[Docket No. 2002–SW–42–AD; Amendment 39–12936; AD 2002–17–51]

Airworthiness Directives; Agusta S.p.A. Model A109E Helicopters

2002-17-51 Augusta S.p.A.: Amendment 39-12936. Docket No. 2002-SW-42-AD.

FIGURE 1

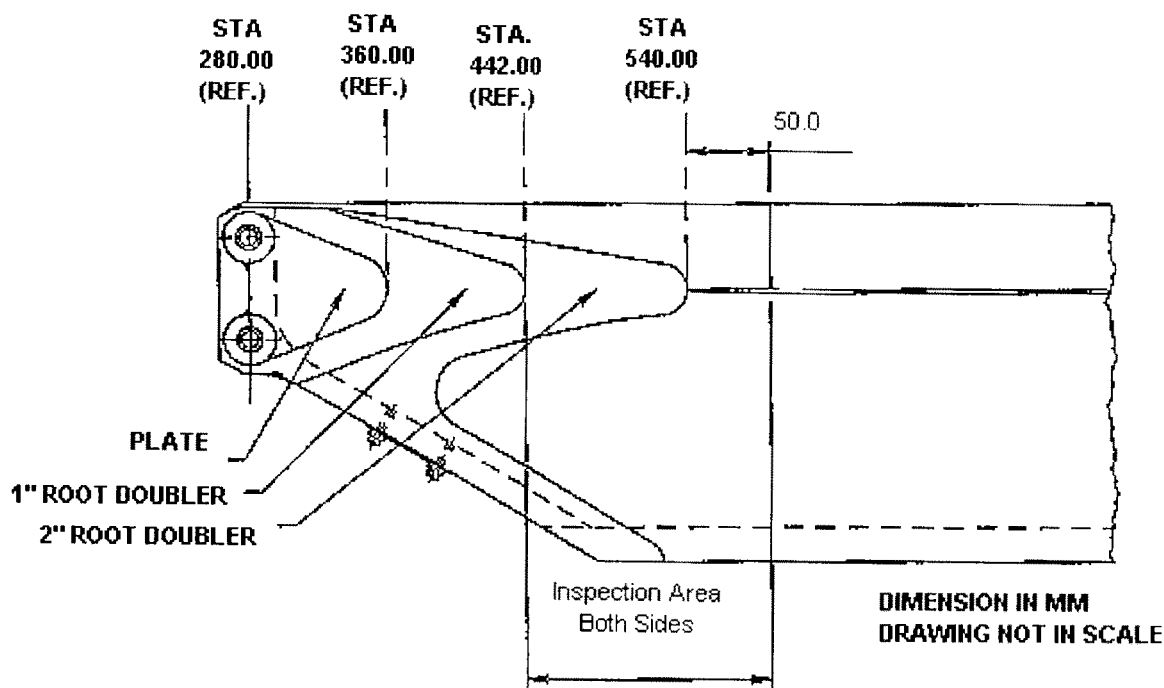
(b) Before each start of the helicopter engines, visually check both sides of each tail rotor blade for a crack in the area depicted in Figure 1 of this AD. And owner/operator (pilot) holding at least a private pilot certificate may perform this visual check and must enter compliance with this paragraph into the aircraft maintenance records in accordance with 14 CFR 43.11 and 91.417(d)(2)(v). See Figure 1:
